Product or Process Change Notice Approval (Customer)

PCN Number: PCN-0003-2014

Title: Change Product Part Number due to Change on the Coding Matrix. Change from ACT8945AQJ303-T to ACT8945AQJ305-T.

ACT8945AQJ305-T Enable/Disable Sequence

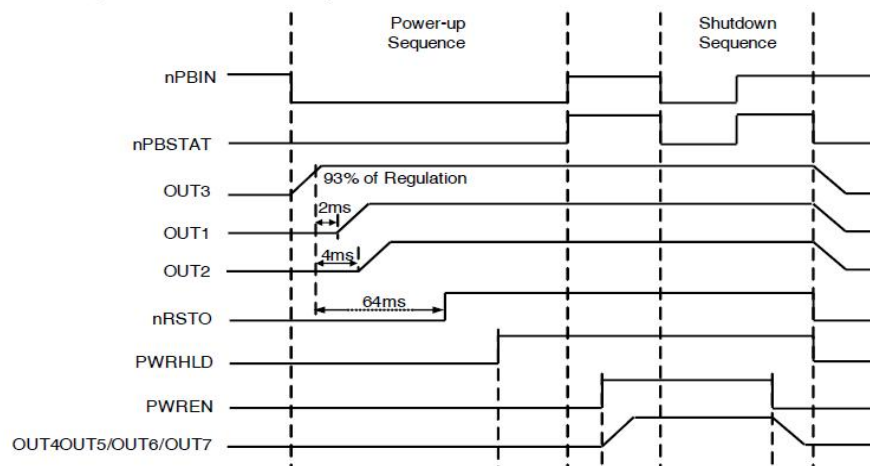
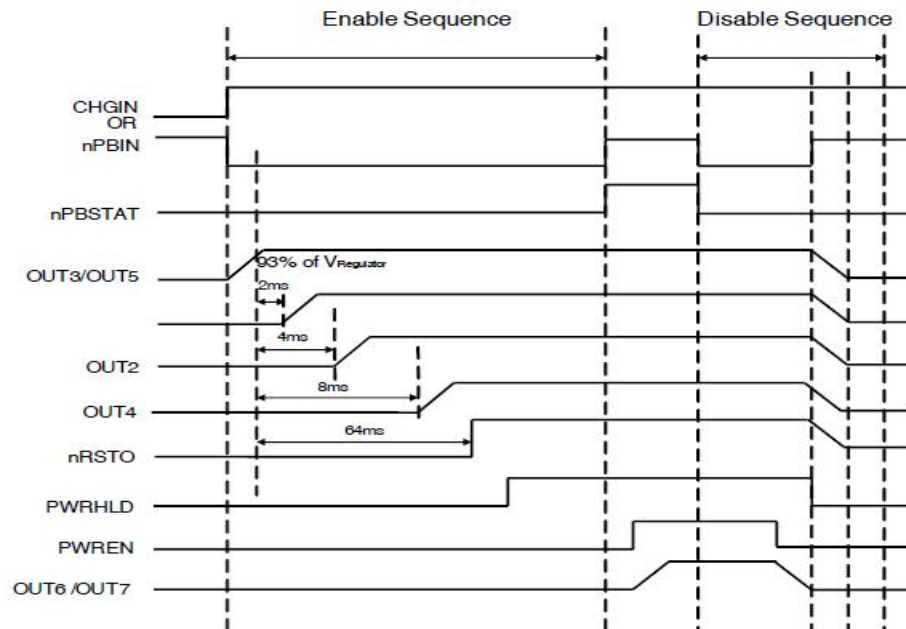
ACT8945AQJ305-T (AA33KY) is customized for Atmel's secure applications which will be used in 3 Platforms and 6 Applications based on ACT8945AQJ303-T; maybe it'll be used in SAM9-S5 platform, too. And the following is the only change based on ACT8945AQJ303-T:

1. OUT4=2.5V default on
2. OUT5=3.3V default on
